**Subject: Beaver Valley Power Station, Unit No. 1 and No. 2  
BV-1 Docket No. 50-334, License No. DPR-66  
BV-2 Docket No. 50-412, License No. NPF-73  
Supplemental Information in Support of 2001-2002 Steam Generator  
Tube Outages Inspection Reports**

**Letter L-03-110 - ATTACHMENT A**

**Information in Response to a Request for Additional Information  
for Beaver Valley Power Station, Unit No. 2**

**Enclosure 1 to NRC letter dated June 4, 2003**

FIGURE 1

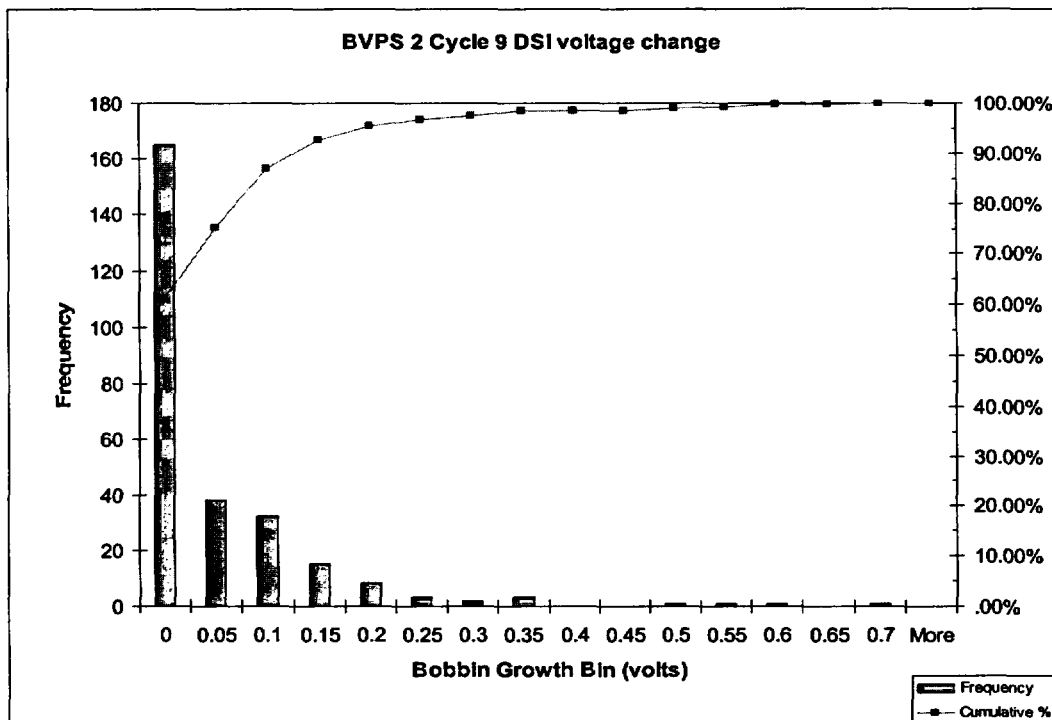
Please trend the number of distorted support plate indications (DSIs) at tube support plate intersections over time. Provide a summary of the growth rate for those indications with time. For the DSIs that were confirmed as flaws with the +Point probe, discuss the history of these indications. Compare the percentage of DSI indications showing measurable growth to the percentage of DSI indications that had a flaw identified by +Point examination. Discuss what actions, if any, have been taken to investigate the reason for the high percentage of DSIs that do not confirm as flaws during the +Point examination.

Additionally, the overall DSI amplitude growth for BVPS 2 Cycle 9 is negligible. The largest singular bobbin amplitude growth in any SG was 0.70 volts, with an average growth of -0.03 volts. Figure 1 provides a cumulative probability distribution function of DSI growth for Cycle 9. An overwhelming majority of the growth values are within the typical repeatability bounds for the bobbin coil.
